ADDENDUM 1

ADDENDUM DATE: April 9th, 2019

PROJECT: OCSC Expansion - Phase 1, Seymour Center
2551 Homestead Rd.
Chapel Hill, NC 27516

The following is a list of changes that have been made to the plans since the issuance of bid documents. These changes are as a result of Town review comments.

L201

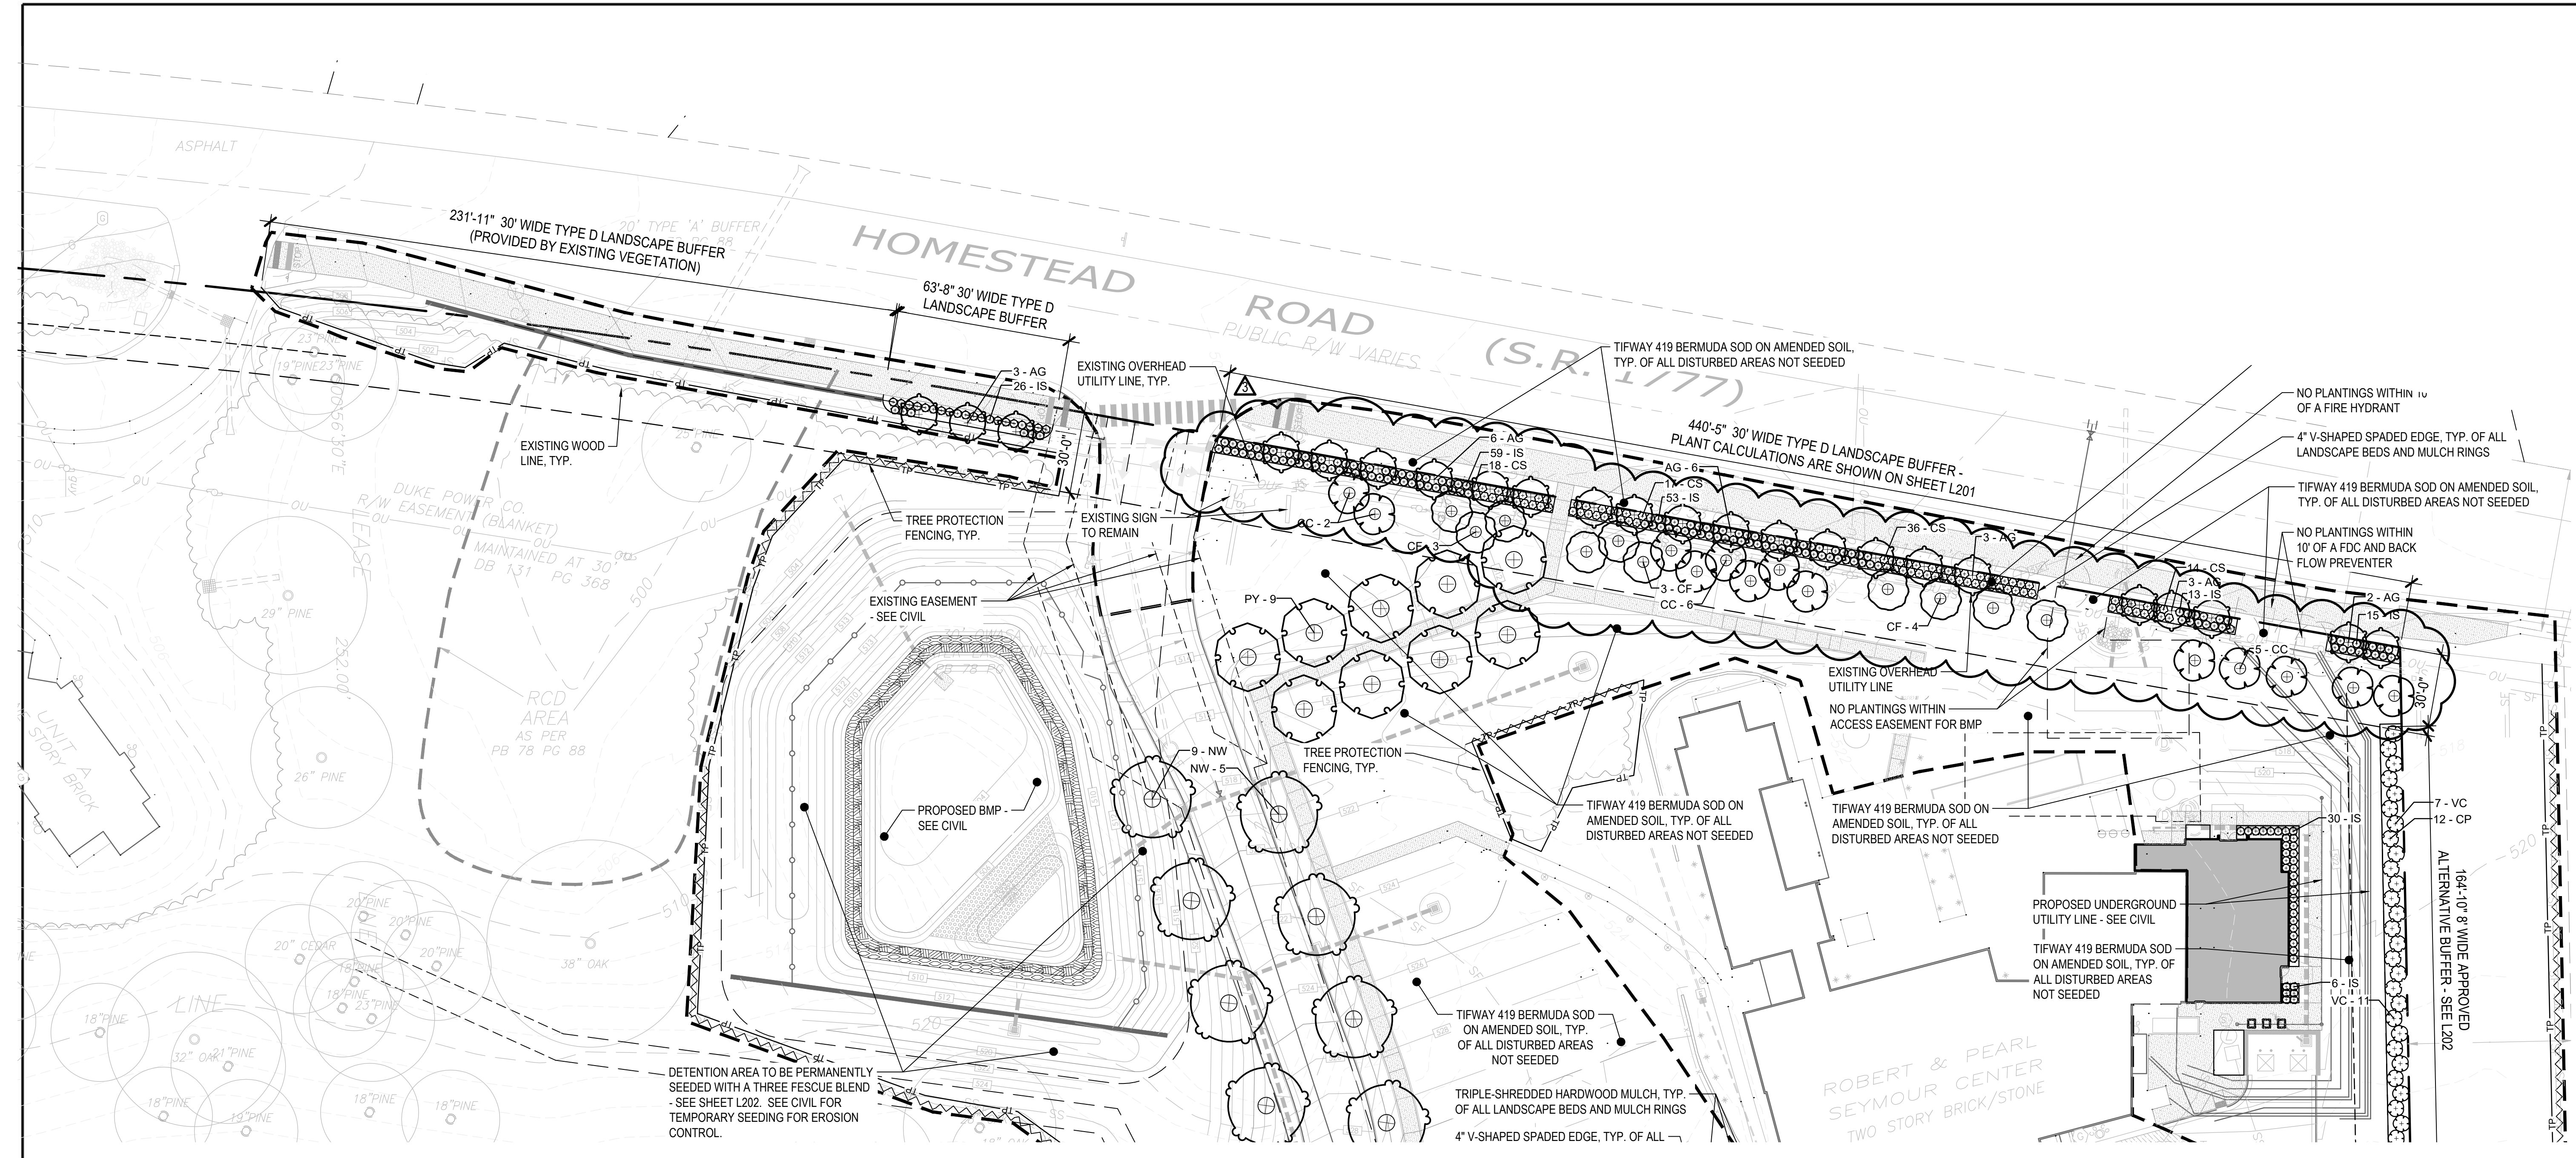
8. The landscaping on the north side of the building along Homestead Road has been modified. (Refer to sheet L201)
9. The landscaping seeding schedule has been updated on sheet L202. (Refer to sheet L202)
